RAI Volume 2, Chapter 2.1.1.4, Eighth Set, Number 5:

RAI Volume 2, Chapter 2.1.1.4, Eighth Set, Number 6:

Clarify how event sequence probability is determined for each initiating event identified under a “small bubble” (e.g., Figure F-3, BSC 2008ab).

Figure 1. DPC ESD03 Event Tree

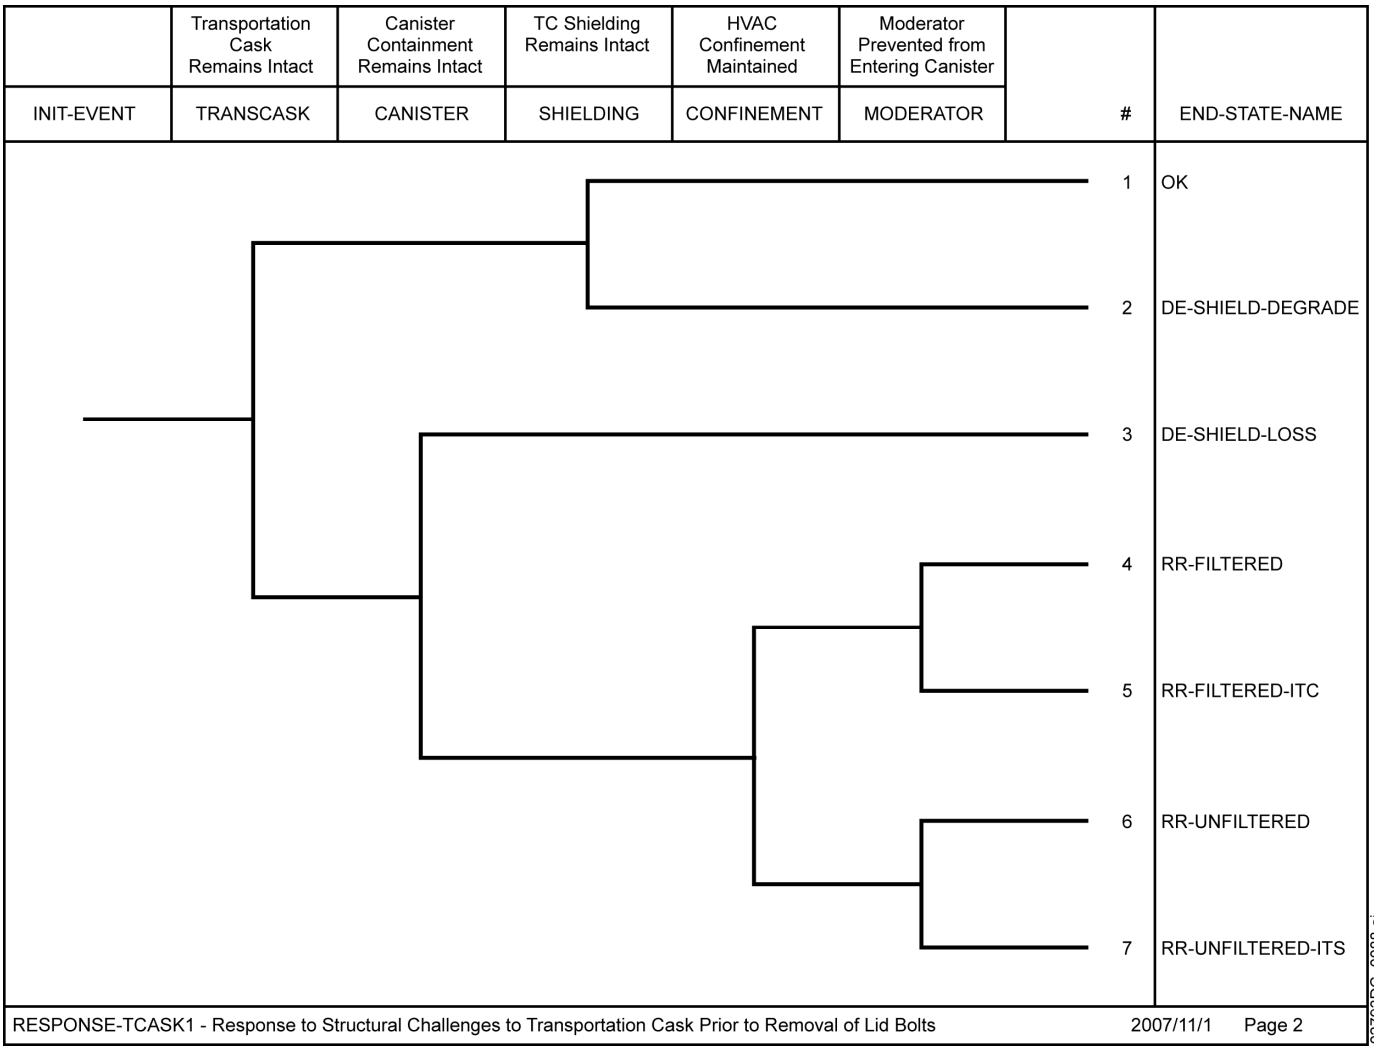
DOE has grouped several initiating events under a “small bubble.” For example, event sequence diagram CRC-ESD-03 (Figure F-3, BSC 2008ab) shows that “TC [transportation cask] drop from operational height” during upending and transfer of transportation cask to the Cask Transfer Trolley operations (represented by the small bubble) can potentially occur due to six independent initiating events. However, it is not clear how DOE has determined the event sequence probability for each independent initiating event.

In summary, to quantify an event sequence, the initiating event frequency (or expected number of occurrences) of an initiator tree branch (e.g., “Drop of Cask” in Figure 1) is multiplied by the number of waste forms handled and then multiplied by the conditional probability of each subsequent pivotal event node (in the system response event tree) in an event sequence until an end state is reached. The initiator event tree CRCF-ESD03-DPC (Figure 1) coupled to the system response event tree (RESPONSE-TCASK1 in Figure 2) provides an example of how event sequences emanating from a small bubble are quantified. The first branch on the left of Figure 1 (labeled “Number of TCs Containing DPCs Processed During Preclosure Period”) represents the number of transportation casks (TCs) containing a dual-purpose canister (DPC) that will be processed over the preclosure period. This number (TC-DPC) is then multiplied by each of the six probabilities associated with each initiator event branch. For example, TC-DPC is multiplied by the frequency of “Drop of Cask.” “Drop of Cask” is the event tree equivalent of the small bubble “TC drop from operational height.” Each of these six branches uses its initiating event fault tree to develop the causative contributors and frequencies. For example, the “Drop of Cask” branch is quantified with fault tree ESD3-DPC-DROP.

This RAI specifically addresses CRC-ESD-03 (BSC 2008, Figure F-3), small bubble “TC dropped at operational height.” In the following discussion of this event sequence diagram, the DPC waste form was chosen as the example for text, figures, and tables. Figure 1 shows the SAPHIRE initiator event tree developed from the event sequence diagram with the specific initiating event (“Drop of Cask”) identified in blue. This transfers into the response tree depicted in Figure 2. To quantify the initiating event fault tree (“DPC Hi Star Cask Dropped”), all events listed under the small bubble (Table 1) are considered. All of these events are contributors to initiating event fault tree ESD3-DPC-DROP. Events CRC-501, CRC-510, CRC-704, CRC-902, and CRC-1001 have been combined into a “200 ton crane drop fault tree” (060-3-DPC-CRANE-DROP), as operational crane drop data does not discriminate among various causes of a crane drop. Event CRC-901, “Cask tilting frame failure causes cask drop,” has also been considered and was developed into basic event 060-TILTFRAME-CSC-FOH.
